SERVICE LETTER

Service Letter Number: SL-001

Subject: DRY AIR PUMP SHEAR COUPLING SERVICE LIFE

Coupling Assembly Kit Part Number: 82-06768

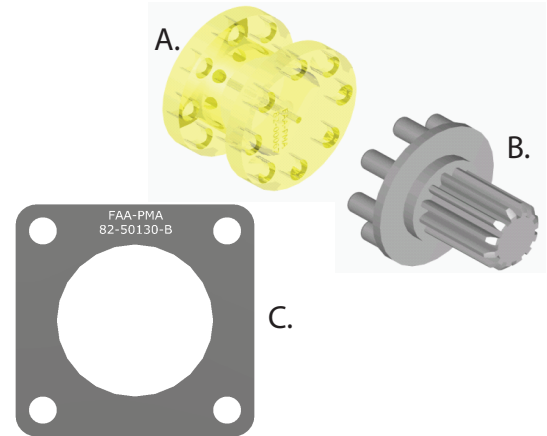
Conditions such as heat, oils, solvents may shorten the useful life of the urethane shear coupling. To prevent failure, Aero Accessories, Inc. recommends the coupling be replaced every six (6) years. The shear coupling must be replaced by an authorized mechanic.

| A. 1 each Shear Coupling | P/N 82-00067 |
| B. 1 each External Drive | P/N 82-00068 |
| C. 1 each Mounting Gasket | P/N 82-50130-B |
